Date: 07/16/18
To: MQ Power Generator Owners
From: MQ Power Product Department
Subject: Camlok 4/0 Cable Replacement — **Mandatory Update**

**DCA400SSI4F, DCA400SSI4FP and DCA400SSI4FSG Generators
Camlok 4/0 Cable Replacement**

Product Group: Power Solutions	Date Issued: Rev 1 — 7/16/18	Service Bulletin No. GSP20180703
Bulletin Type <input checked="" type="checkbox"/> Mandatory <input type="checkbox"/> Information Only <input type="checkbox"/> Recommended Change		Models/Series Affected: DCA400SSI4F S/N 3929073 – 3929078 DCA400SSI4FP S/N 3927637, 3927638, 3927641, 3927642, 3927645, 3927646, 3927649 – 3927652 DCA400SSI4FSG 3928432, 3928433, 3928438 – 3928441, 3928443 – 3928452

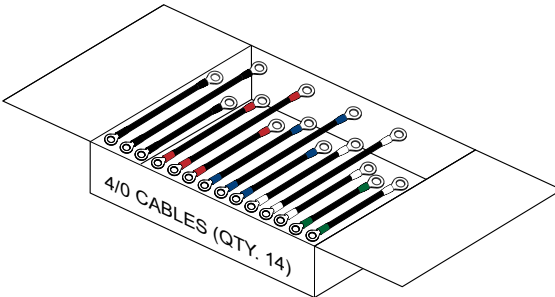
Details Problem: 4/0 cables between the output terminal and camlok panel are improperly crimped. Solution: Replace cables.

Parts Information  <p style="text-align: center;">Figure 1. Camlok Cable Kit</p>	<table border="1"> <thead> <tr> <th>Item No.</th> <th>Part No.</th> <th>Description</th> <th>Qty.</th> <th>Remarks</th> </tr> </thead> <tbody> <tr> <td>1</td> <td>EE60437</td> <td>DCA400SSI4F Camlok Cable Kit</td> <td>1</td> <td></td> </tr> </tbody> </table>	Item No.	Part No.	Description	Qty.	Remarks	1	EE60437	DCA400SSI4F Camlok Cable Kit	1	
Item No.	Part No.	Description	Qty.	Remarks							
1	EE60437	DCA400SSI4F Camlok Cable Kit	1

Figure 2. Bolt Removal

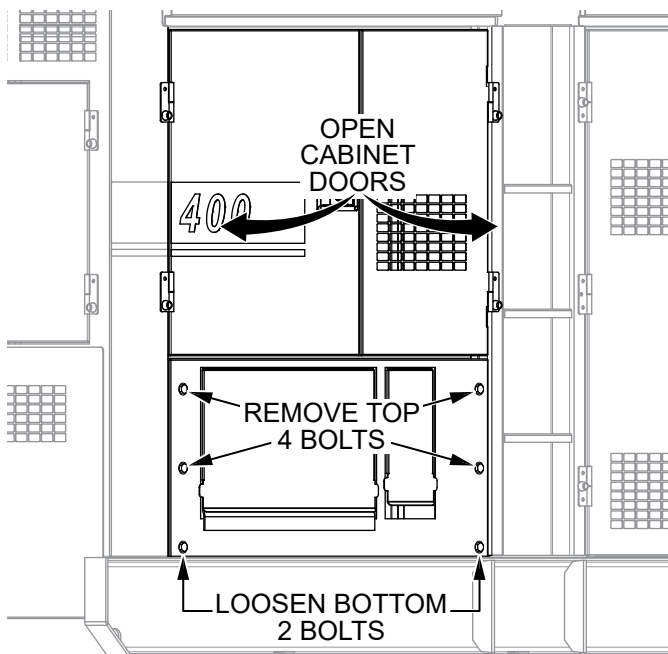
2. Using a 13 mm socket or open-end wrench, remove the top four bolts securing the output panel to the frame (Figure 2). Set the bolts aside for later.

3. **LOOSEN**, but **DO NOT REMOVE**, the bottom two bolts securing the output panel to the frame (Figure 2).
4. Open the output panel and tilt it outward (Figure 3) to provide interior access to the camlok panel. Wedge a wood block or similar object in between the panel and the frame to keep the panel open.

Figure 3. Camlok Panel Access

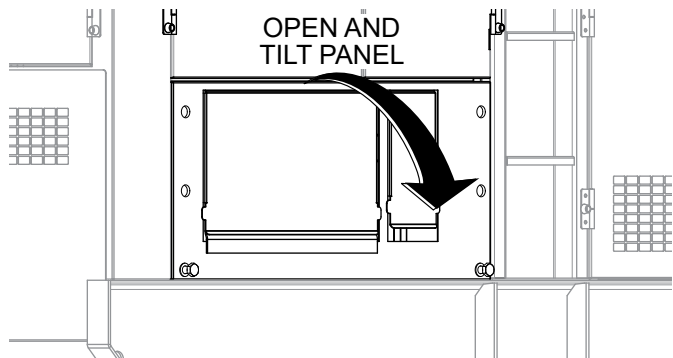
5. Place a small step ladder just below the panel opening.
6. Using a 13 mm socket or open-end wrench, remove the seven bolts securing the interior camlok panel cover to the frame.
7. Set the interior camlok panel cover and mounting hardware aside.

Figure 4. Ring Terminal Orientation

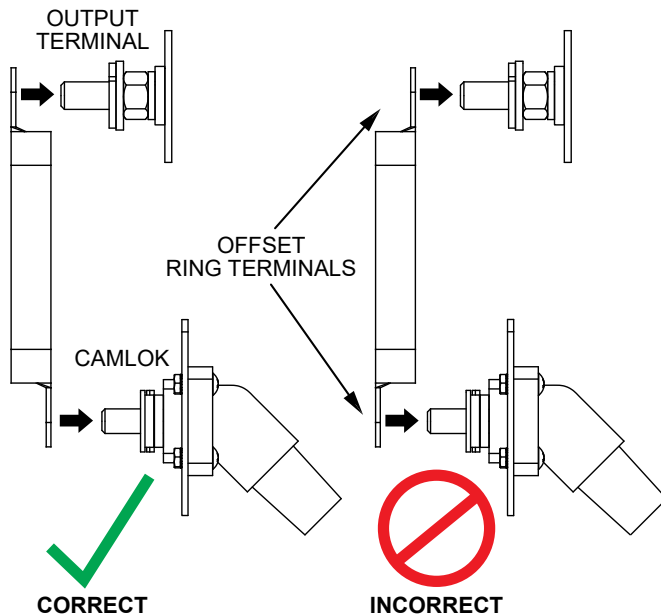
The new 4/0 cables have **offset ring terminals**. Be sure to connect the cables with the **correct ring terminal orientation** as shown in Figure 4. If the cables are connected incorrectly, it will be difficult or impossible to fit all of the other wire connectors onto the output terminals.

Figure 5. Output Terminal Panel To Camlok 4/0 Cable Wiring

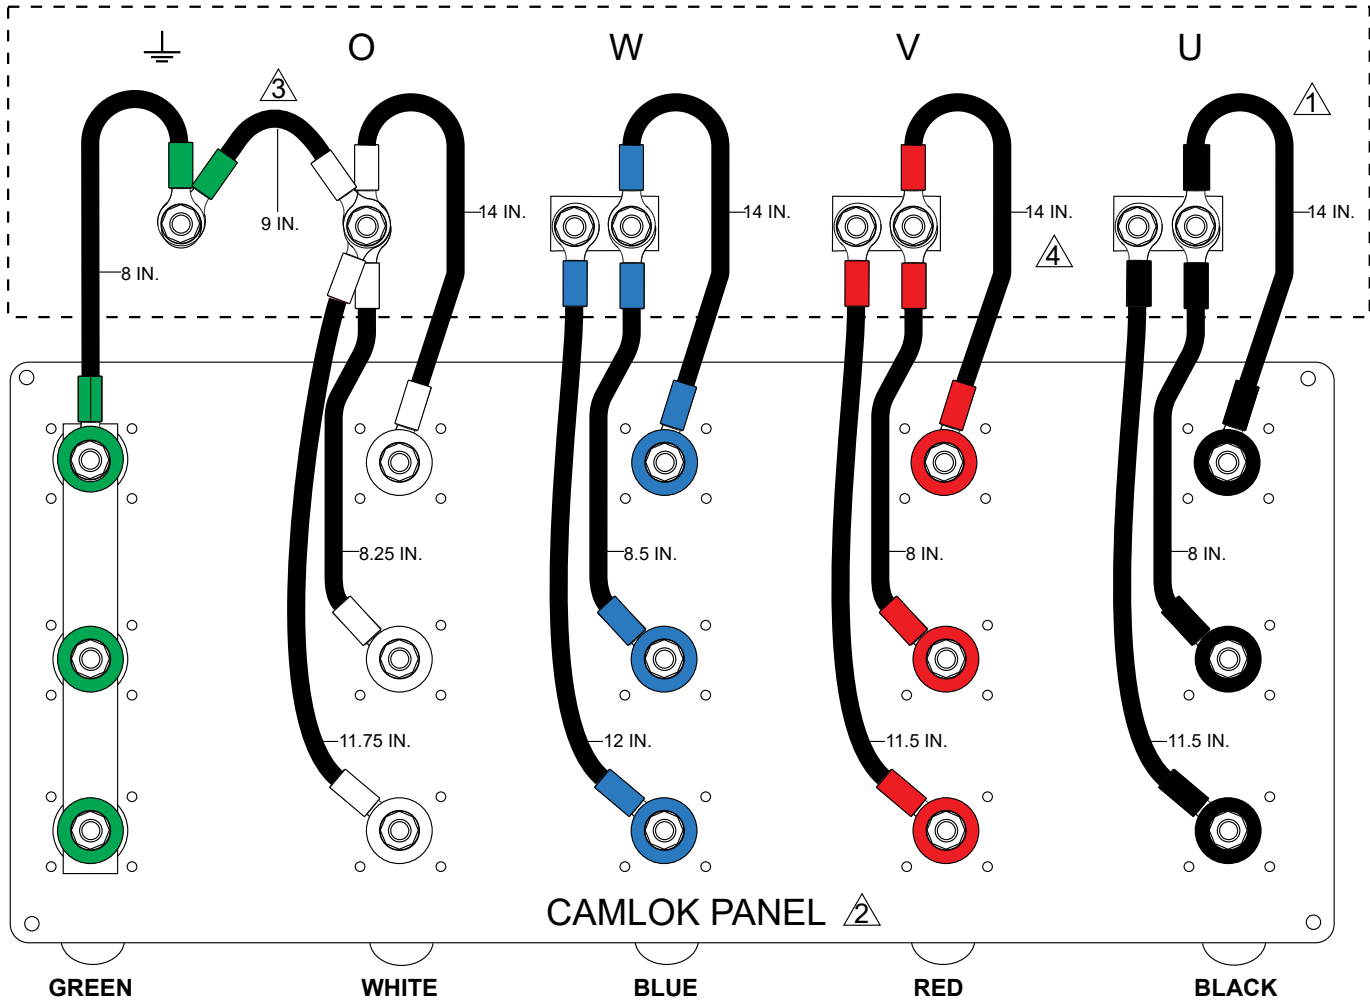
1. Using a 1-3/16" socket, remove the **three 4/0 cables** connected between the **U** terminal on the output terminal panel and the camlok panel (Figure 5).
2. Install **three replacement 4/0 cables** between the **U** terminal on the output terminal panel and the camlok panel (Figure 5). **Pay close attention to the cable lengths and color code markings.**

3. To prevent arcing, tighten the output terminal to 95 ft-lb (128.8 N·m). Tighten the camlok terminals to 45 ft-lb (61 N·m).
4. Repeat this procedure for the **V** and **W** terminals on the output terminal panel.

5. Remove the **three 4/0 cables** connected between the **O** terminal on the output terminal panel and the camlok panel (Figure 5).
6. Remove the **white** end of the **existing 4/0 bonding jumper** from the **O** terminal (Figure 5).

7. Install **three replacement 4/0 cables** between the **O** terminal on the output terminal panel and the camlok panel (Figure 5). **Pay close attention to the cable lengths and color code markings.**

8. Install the **white** end of the **replacement 4/0 bonding jumper** onto the **O** terminal (Figure 5).
9. Tighten the output terminal to 95 ft-lb (128.8 N·m). Tighten the camlok terminals to 45 ft-lb (61 N·m).

10. Remove the **4/0 cable** connected between the **GROUND** terminal on the output terminal panel and the camlok panel (Figure 5).
11. Remove the **green** end of the **existing 4/0 bonding jumper** from the **GROUND** terminal on the output terminal panel (Figure 5).

12. Install the **new 4/0 cable** between the **GROUND** terminal on the output terminal panel and the camlok panel as shown in Figure 5.

13. Install the **green** end of the **new 4/0 bonding jumper** onto the **GROUND** terminal (Figure 5).
14. Tighten the output terminal to 95 ft-lb (128.8 N·m). Tighten the camlok terminal to 45 ft-lb (61 N·m).
15. **MAKE SURE** no cables or wires are making contact with another phase. There should be space in between the cables for each phase. See Figure 5.

- ① CONNECT 4/0 WIRES 14 PLACES
- ② TERMINAL CAPS AND ADDITIONAL WIRING NOT SHOWN FOR CLARITY
- ③ BONDING JUMPER
- ④ LEAVE SPACE BETWEEN PHASES
